VALUE ENGINEERING CHANGE PROPOSAL MISSOURI DEPARTMENT OF TRANSPORTATION

Contract ID 091120-201 Job No. J2P0780

SUBJECT: District Recommendation on VE Proposal #1
J2P0780/Rte. 65, Mercer/Grundy Co.

LOG MILE 27.327 TO LOG MILE 27.420 -
LOG MILE 30.177 TO LOG MILE 36.364 -
(SECTION 5)

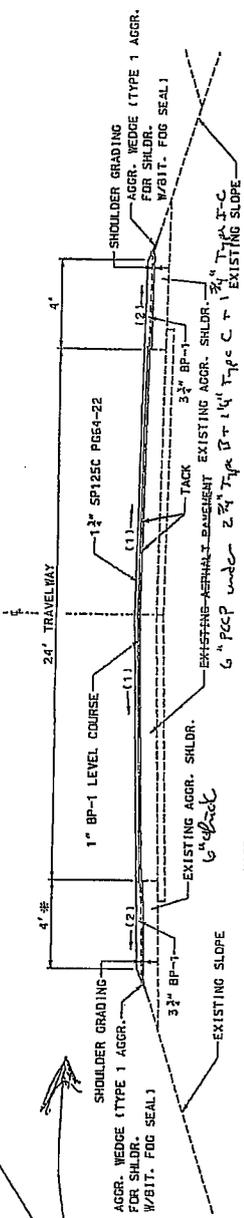
Section 1 and 5 were last overlaid in 1998 and 1997, respectively, with 1 ¾" I-C over 2" I-B in all of Section 1 and 30% of Section 5. The contractor's proposal to mill and fill 1 ¾" for a portion of Section 1 and all of Section 5 would achieve the initial smoothness; however, it would expose the existing I-B mixture to milling. The documentation related to the Pavement Type Selection does not state that the I-B has begun to ravel but does indicate that it has de-bonded from the other asphaltic pavement layers in multiple locations. Exposure of I-B mixtures to milling in other areas of the state has led to unanticipated rutting and this may be possible here. Another issue to consider is the existing pavement structure.

The typical section for Section 1 is asphaltic concrete over PCCP with aggregate shoulders. The PCCP is believed to be in poor condition due to D Cracking and the additional structure provided by the overlay, as designed, would add to the long term stability/durability of the pavement. Similarly, in Section 5 the additional structure would be beneficial due to the condition of the underlying PCCP; however, it would be particularly important from log mile 27.420 to 30.177 where the existing PCCP is only 6" thick. Additionally, in Section 5 the existing 10' shoulders consist of 2" of asphalt over base (4.11 miles) and 3 ¾" of asphalt over base (2.87 miles). The 2" thick shoulders are in fair to poor condition and the 3 ¾" thick shoulders are in fair condition. If the design is modified as proposed it would be advisable to mill the 10' shoulders 3 ¾" deep and fill with BP-1. The remaining shoulders in Section 5 are 6" of Type I Aggregate Base. If the design is modified as proposed the existing aggregate shoulders would not have sufficient depth to construct the new shoulders as shown on the typical sections (3 ¾" of BP-1 over 4" of Aggregate Base). 4" of Type 1 Aggregate Base would need to be installed from log mile 27.420 to 30.177. Basically, if mainline is milled and filled in Section 5 it would require extensive shoulder reconstruction for its entire length (9.037 miles) to achieve the designed level of service.

LOG MILE 27.420 TO LOG MILE 30.177 (SECTION 5)

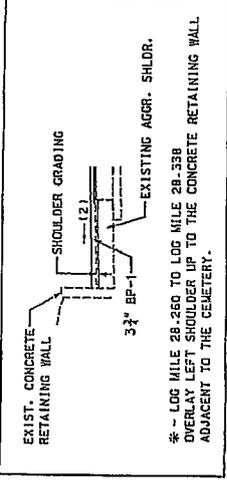
This section was designed to remove only one inch of aggregate material from the shoulder and overlay with 3.75" of BP-1. The design team deemed that the existing aggregate shoulder had sufficient depth to serve as a 4" base, thus creating a Type A3 shoulder. This VE proposal assumes there is at least 7.75" of aggregate base, which our cores showed is not the case. If a mill & fill was used on the traveled way, 7.75" of material would need to be removed from the shoulder and 4" of Type 1 aggregate base would need to be placed under the 3.75" BP-1. This would offset over half of the savings in this section. The remaining savings would be less than the value of the lost structure on the traveled way.

SECTION 5 PVMT HISTORY

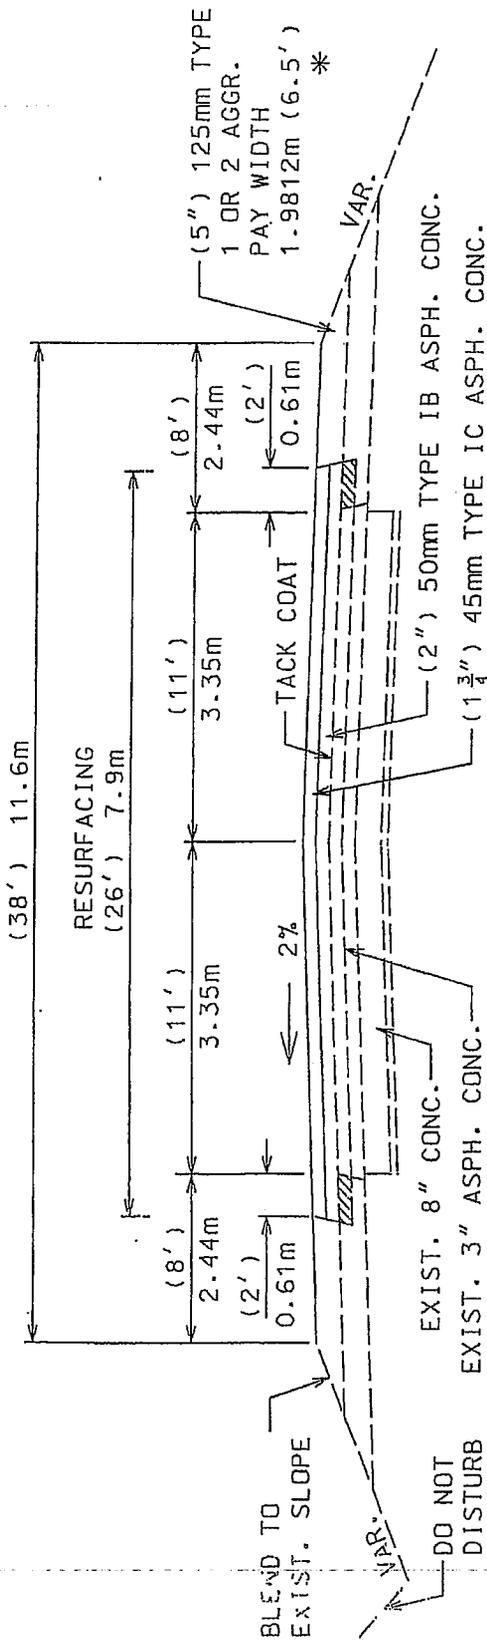
- The contractor is proposing to mill and fill 1.75" for 24' wide. If the contractor's proposal is accepted the pavement section will remain relatively thin for the traffic conditions. Additionally, the shoulder design will need to be modified to add 4" of Type 1 aggregate base as the shoulders would not have sufficient rock depth remaining to support the 3.75" BP-1.

- The contractor is proposing to mill and fill mainline and the shoulders. If the contractor's proposal is accepted there is a possibility that the remaining portion of the I-C mixture will debond (the pavement selection commentary noted the debonding of the newer I-C and I-B layers). Additionally, the existing asphalt shoulder is 2" thick. This will require milling 3.75" and filling with BP-1 to bring the shoulder up to current guidelines.

- The contractor is proposing to mill and fill mainline and the shoulders. If the contractor's proposal is accepted there is a possibility that the remaining portion of the I-C mixture will debond (the pavement selection commentary noted the debonding of the newer I-C and I-B layers). The impact to the shoulders is unknown.

- The contractor is proposing to mill and fill mainline and the shoulders. If the contractor's proposal is accepted it will expose I-B to milling.

- The contractor is proposing to mill and fill mainline and the shoulders. If the contractor's proposal is accepted there is a possibility that the remaining portion of the I-C mixture will debond (the pavement selection commentary noted the debonding of the newer I-C and I-B layers). The impact to the shoulders is unknown.

- The contractor is proposing to mill and fill mainline and the shoulders. If the contractor's proposal is accepted it will expose I-B to milling.
